PIN Title:

Product Information Notice for Package Outline Drawing Change of Selected Products in Flip Chip QFN Package

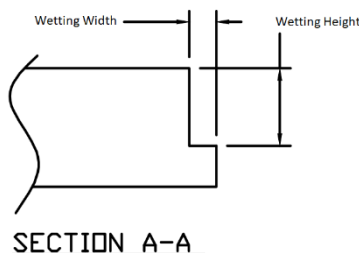
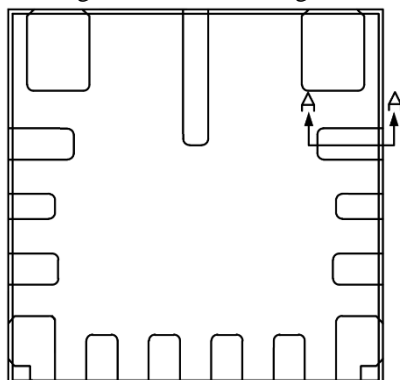
- 1) Wetting height will be changed from 0.1mm ref to 0.065mm min.
- 2) Wetting width will be changed from 0.05mm ref to 0.01mm min - 0.1mm max.

This is a document update only based on process tolerance. POD update still complies with JEDEC package outline drawing.
